AMENDMENT DRAWING

SUPERSEDES 100-EP405T0

Drawing Title: ENLARGED ELECTRICAL ROOM C PLAN - POWER TEMPORARY

Project Title: VA PUGET SOUND HEALTH CARE SYSTEM UPGRADE SEATTLE ELECTRICAL DISTRIBUTION FROM 5kV TO 15kV

ENLARGED MAIN SWITCHGEAR ROOM C - TEMPORARY T6

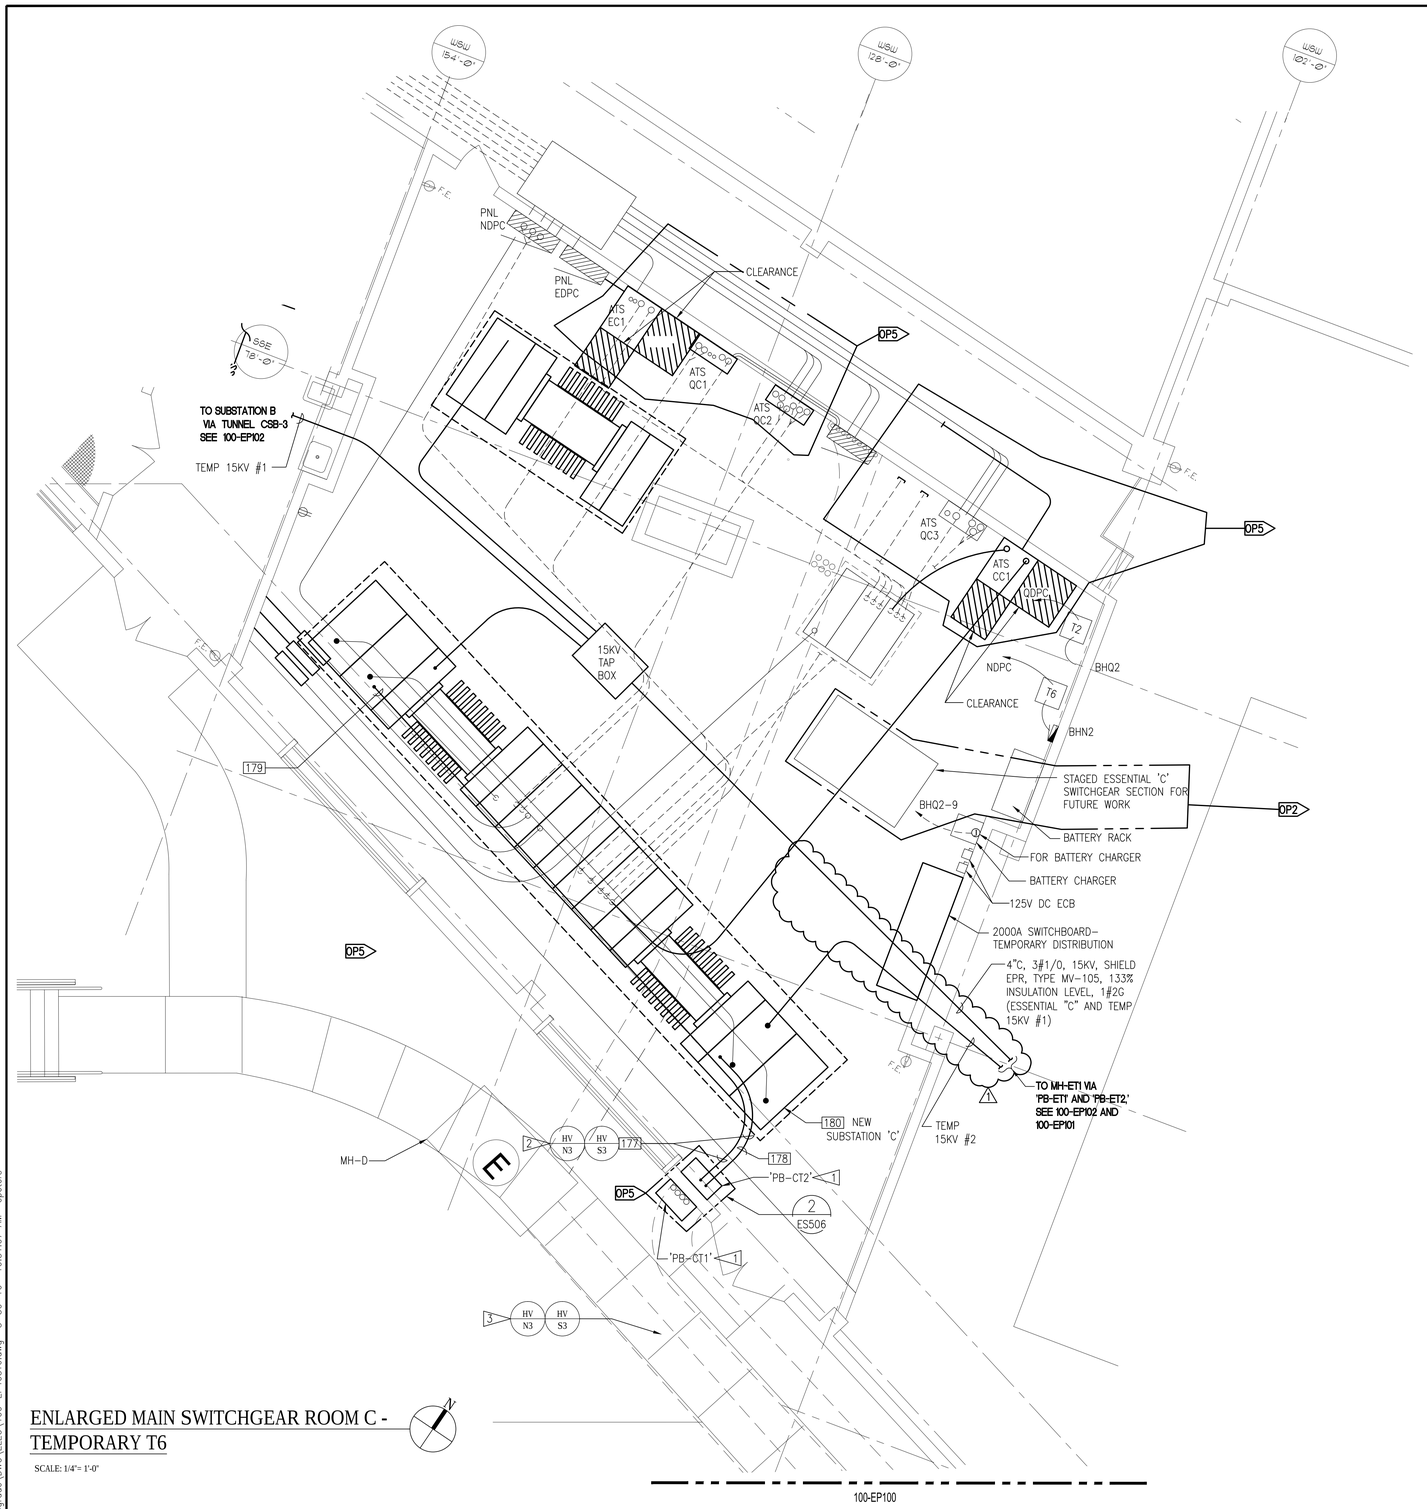
1. PROVIDE STAINLESS STEEL PULL BOX WITH CONTINUOUS HINGE AND LOCKABLE DOOR. SEE 2/ES506 FOR MOUNTING DETAIL. REFER TO 100-EP405T3 FOR ADDITIONAL REQUIREMENTS.
2. PROVIDE CONDUIT AND CABLES.
3. PROVIDE CABLES IN EXISTING DUCTS.

ENLARGED MAIN SWITCHGEAR ROOM C - TEMPORARY T8

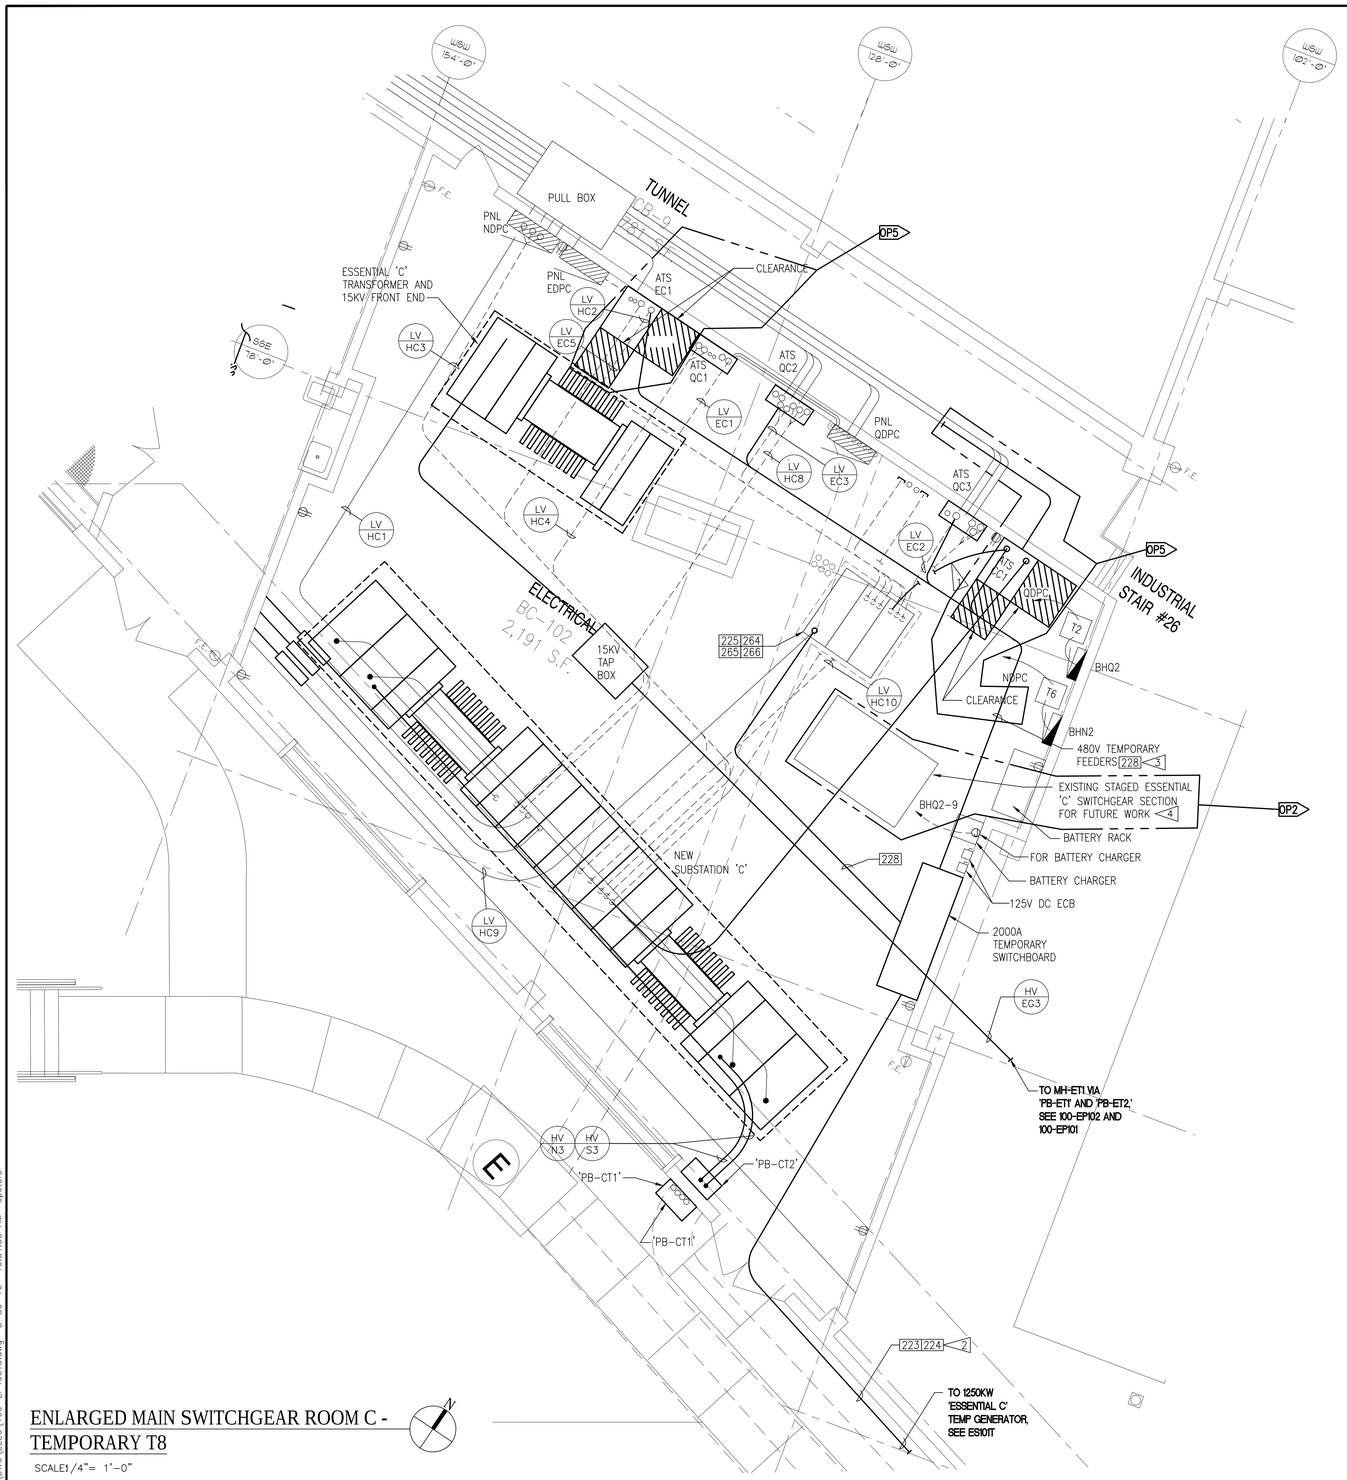
1. PROVIDE TEMPORARY FEEDER. TEMPORARY FEEDER SHALL HAVE MINIMUM OF 2000A CAPACITY, AND RATED FOR OUTDOOR USAGE.
2. INTERCEPT FEEDER ATS CONTROL CIRCUIT AND EXTEND TO TEMP SWITCHBOARD.
3. PROVIDE TEMPORARY FEEDER EQUIVALENT TO EXISTING FEEDER.
4. REPLACE EXISTING ESSENTIAL SWITCHGEAR 'C' WITH STAGED LOW VOLTAGE SECTION.

ENLARGED MAIN SWITCHGEAR ROOM C - TEMPORARY T9

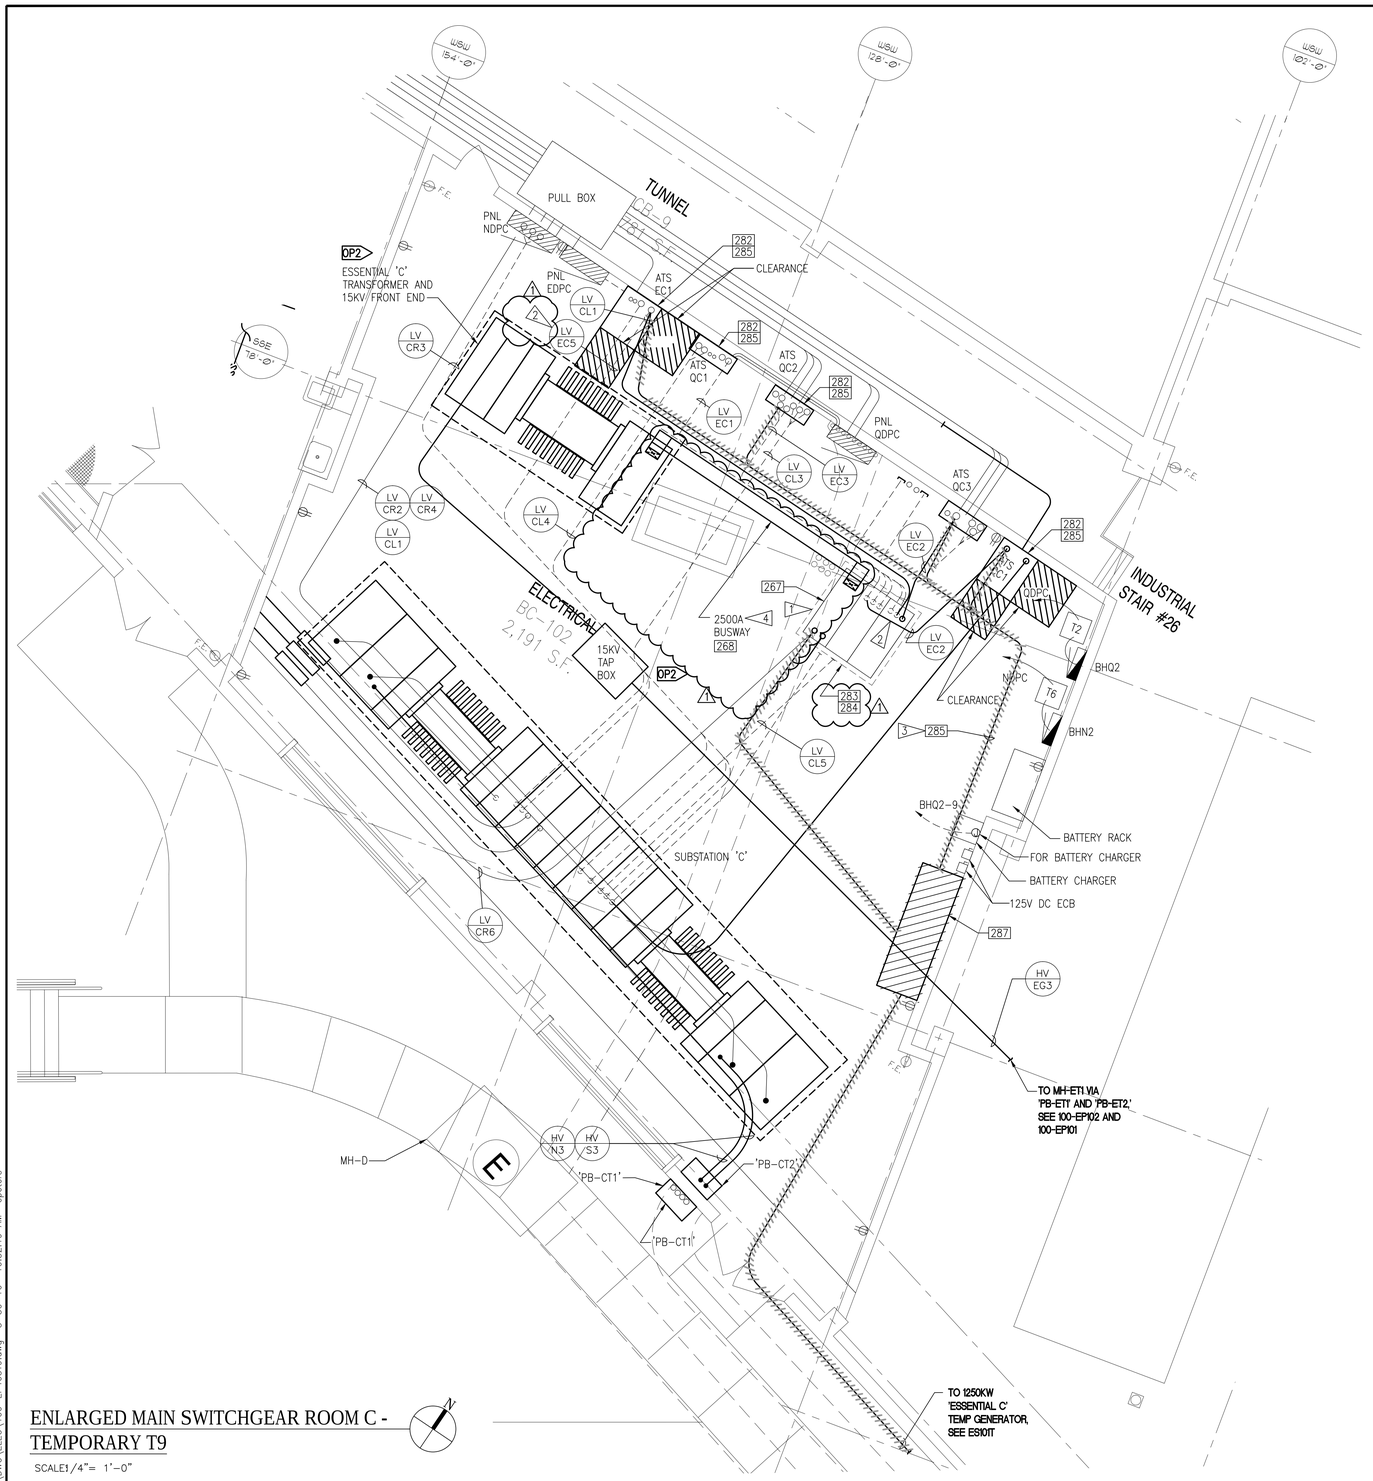
1. COORDINATE HOUSE-KEPING WITH STRUCTURAL.
2. PROVIDE FEEDER AS SHOWN.
3. REMOVE TEMPORARY FEEDERS TO TRANSFER SWITCHES.
4. CONNECT SWITCHGEAR TO TRANSFORMER SECONDARY TERMINALS USING 2500A COPPER BUSWAY. BUSWAY SHALL BE INDOOR FEEDER CONFIGURATION, 3P/4W 100% NEUTRAL WITH 50% INTERNAL GROUND BUS.

1 PROVIDE FIELD FABRICATED SUPPORT AS REQUIRED.

Drawing Title: MAIN SWITCHGEAR ELEVATION AND SCHEDULE

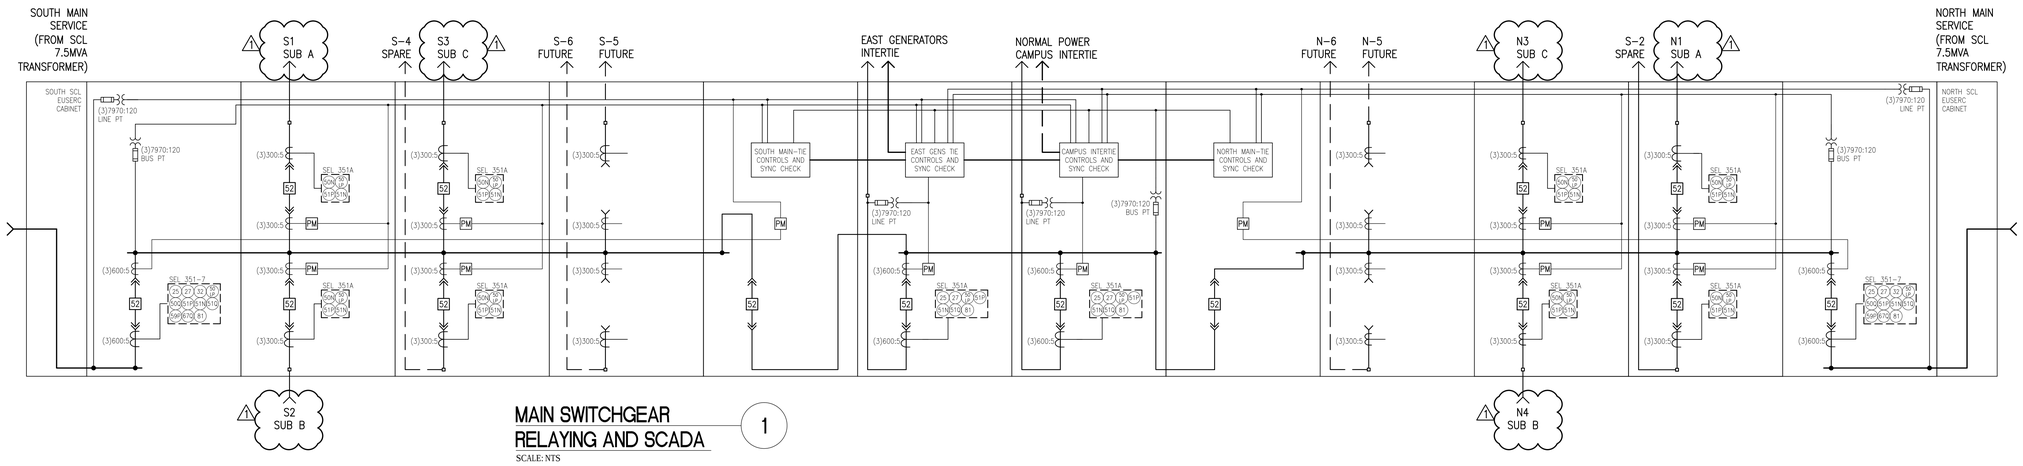
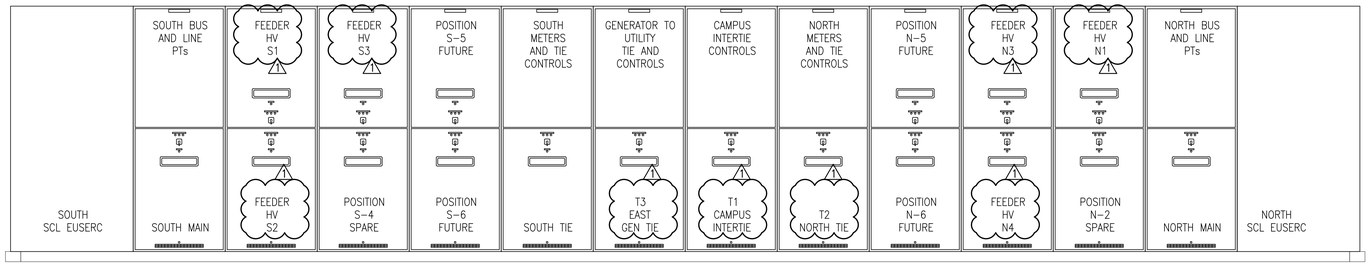
1. MEDIUM VOLTAGE SWITCHGEAR SHALL BE RATED 1200A, 15KV, 23KAIC 2-SEC, 37KAIC CLOSE AND LATCH.
2. MEDIUM VOLTAGE BREAKERS SHALL BE SAME MAKE AND MODEL THROUGHOUT.

THE AUTOMATIC THROWOVER SYSTEM SHALL CONTROL THE TWO (2) MAIN BREAKERS AND THE (2) BUS TIE BREAKERS IN CASE OF LOSS OF VOLTAGE AT EITHER SERVICE CONNECTION. FOR ALL CONDITIONS LISTED AS FOLLOWS, NORMAL VOLTAGE IS DEFINED AS BETWEEN PLUS 6% AND MINUS 13% OF STEADY-STATE SYSTEM NOMINAL VOLTAGE, LINE-TO-LINE AND LINE-TO-NEUTRAL AS APPLICABLE, AT FREQUENCY 60 HZ PLUS OR MINUS 0.5%.

THE AUTOMATIC THROWOVER SYSTEM SHALL BE DISABLED IF EITHER THE GENERATOR INTERTIE OR CAMPUS NORMAL POWER INTERTIE IS ACTIVE.

1. NORMAL VOLTAGE ON BOTH SERVICE CONNECTIONS:
   - A. BOTH MAIN BREAKERS ARE CLOSED.
   - B. BOTH BUS TIE BREAKERS ARE OPEN.
2. NORMAL VOLTAGE ON EITHER SERVICE CONNECTION, OVERCURRENT EVENT ON THE OPPOSITE MAIN BREAKER.

- A. BUS TIE BREAKER CLOSEST TO THE TRIPPED MAIN BREAKER SHALL NOT CLOSE.
   - B. AUTOMATIC TRANSFER OPERATIONS SHALL BE BLOCKED TO PREVENT CLOSING INTO A POTENTIALLY FAULTED BUS.

- C. UPON RESET OF THE TRIPPED BREAKER, AUTOMATIC TRANSFER OPERATIONS SHALL BE PERMITTED.
3. NORMAL VOLTAGE ON EITHER SERVICE CONNECTION, LOSS OF NORMAL VOLTAGE ON THE OTHER SERVICE CONNECTION:

- A. BREAKER ON THE SERVICE FEEDER WHERE THERE HAS BEEN LOSS OF NORMAL VOLTAGE SHALL OPEN AFTER AN ADJUSTABLE TIME DELAY OF 0 TO 10 SECONDS, SET INITIALLY AT 1.5 SECONDS.

- B. BUS TIE BREAKERS SHALL CLOSE IMMEDIATELY THEREAFTER.
4. LOSS OF NORMAL VOLTAGE ON ONE SERVICE FEEDER AND VOLTAGE IS NOT NORMAL ON THE OTHER (TARGET) SERVICE FEEDER:

- A. BREAKER ON THE SERVICE FEEDER WHERE THERE HAS BEEN LOSS OF NORMAL VOLTAGE SHALL OPEN AFTER AN ADJUSTABLE TIME DELAY OF 0 TO 10 SECONDS, SET INITIALLY AT 1.5 SECONDS.

- B. BUS TIE BREAKER CLOSEST TO THE TARGET SERVICE SHALL NOT CLOSE.
   - C. AT SUCH TIME THAT VOLTAGE BECOMES NORMAL ON THE TARGET SERVICE FEEDER FOR A TIME-ADJUSTABLE DURATION, THE BUS TIE BREAKER SHALL CLOSE. THE ADJUSTABLE DELAY SHALL BE 0 TO 10 SECONDS, SET INITIALLY AT 1.5 SECONDS.

5. LOSS OF VOLTAGE ON BOTH SERVICE FEEDERS SIMULTANEOUSLY, OR SEQUENTIAL LOSS OF A TARGET FEEDER WITHIN THE TIME DELAY FOR THE FIRST FEEDER TO OPEN ITS MAIN BREAKER:

- A. MAIN BREAKER ON THE SERVICE FEEDER OR FEEDERS WHERE THERE HAS BEEN LOSS OF VOLTAGE SHALL OPEN AFTER AN ADJUSTABLE TIME DELAY OF 0 TO 10 SECONDS, SET INITIALLY AT 1.5 SECONDS.

- B. IF BOTH MAIN BREAKERS HAVE OPENED, OR EITHER SERVICE FEEDER LOSES NORMAL VOLTAGE WHILE THE OTHER MAIN BREAKER IS IN TIME DELAY BEFORE OPENING, THE BUS TIE BREAKERS SHALL NOT CLOSE.

6. FOLLOWING AN AUTOMATIC TRANSFER OPERATION AND SUBSEQUENT RESTORATION OF NORMAL VOLTAGE ON A SERVICE FEEDER FOR WHICH ITS MAIN BREAKER WAS OPENED:
   - A. BUS TIE BREAKER CLOSEST TO THE OPEN MAIN BREAKER SHALL OPEN AFTER AN ADJUSTABLE TIME DELAY OF 0 TO 30 MINUTES, SET INITIALLY AT 5 MINUTES.

- B. MAIN BREAKER ON RESTORED SERVICE SHALL CLOSE.
   - C. ON CONFIRMATION OF CLOSED MAIN BREAKER, THE OTHER BUS TIE BREAKER SHALL OPEN.
7. AT ALL TIMES, INTERLOCKS SHALL PREVENT PARALLELING THE TWO INCOMING SERVICE FEEDERS.

Drawing Title: MCC ELEVATIONS

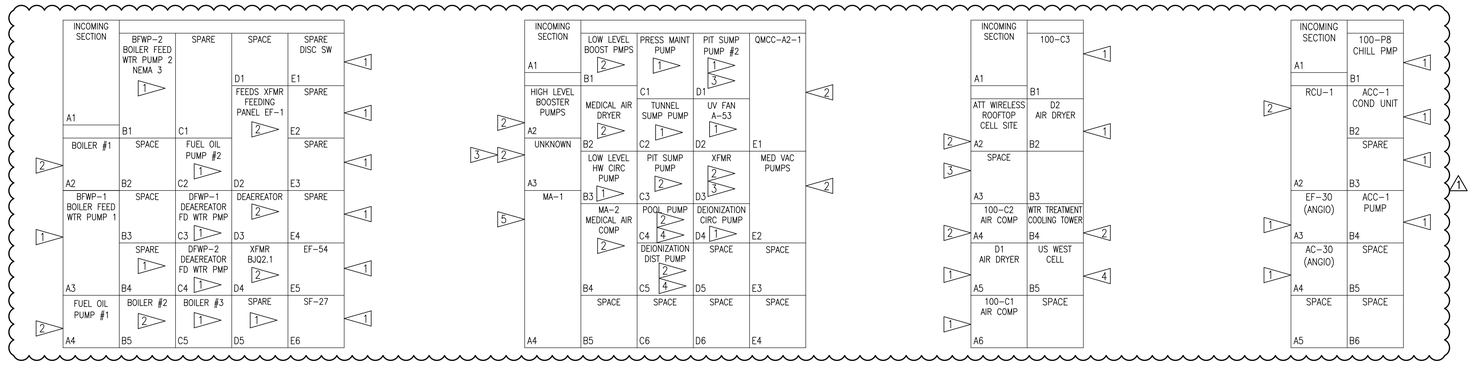
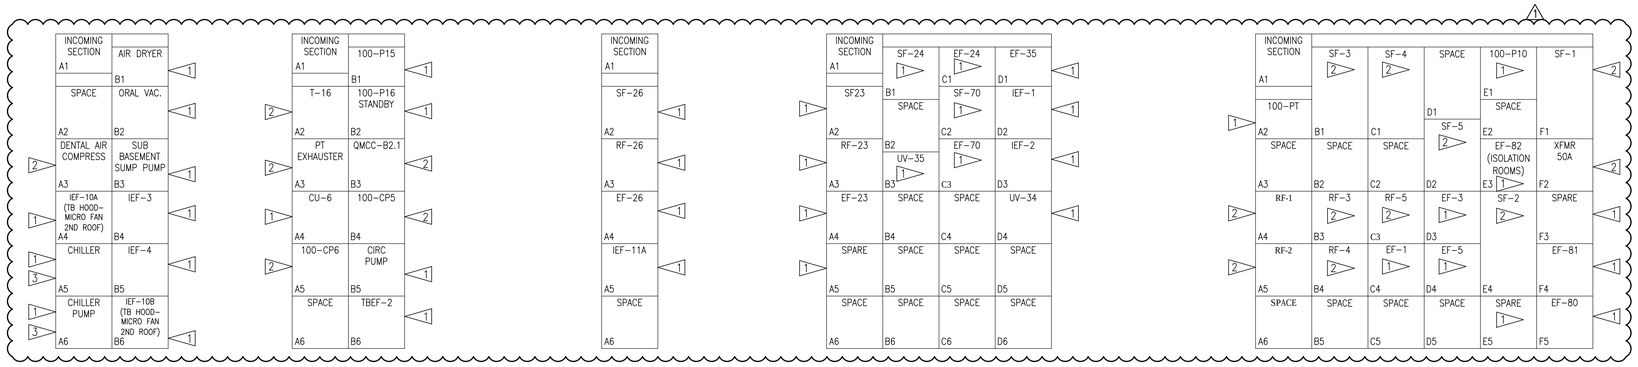
1. REFER TO MCC SCHEDULES ON DRAWINGS 100-EP801, 100-EP802 AND 100-EP803 FOR ADDITIONAL WORK.
2. COORDINATE SHUT DOWN OF ALL EQUIPMENT WITH OWNERS' REPRESENTATIVE PRIOR TO START OF WORK.
3. RECONNECT ALL BRANCH FEEDERS AND CONTROL WIRING.
4. PROVIDE LABELS ON NEW BUCKET SWITCH ENCLOSURES.

1. REPLACE EXISTING BUCKET WITH NEW CONSISTING OF CIRCUIT BREAKER, STARTER, OVERLOAD RELAYS, PILOT LIGHTS, HOA SWITCH, OPERATING HANDLE, CONTROL POWER TRANSFORMER, RESET BUTTON AND ALL APPURTENANCES TO PROVIDE A COMPLETE AND WORKING BUCKET SWITCH.
2. REPLACE EXISTING BUCKET WITH NEW CONSISTING OF CIRCUIT BREAKER AND OPERATING HANDLE.
3. FIELD VERIFY EQUIPMENT SERVED. REDLINE AS-BUILT DRAWINGS AND RETURN TO VA, RESIDENT ENGINEER (RE).
4. COORDINATE WITH VA RE IF EQUIPMENT IS IN SERVICE. PROVIDE BUCKET SWITCH AS REQUIRED.
5. EXISTING BUCKET SWITCH SHALL REMAIN.
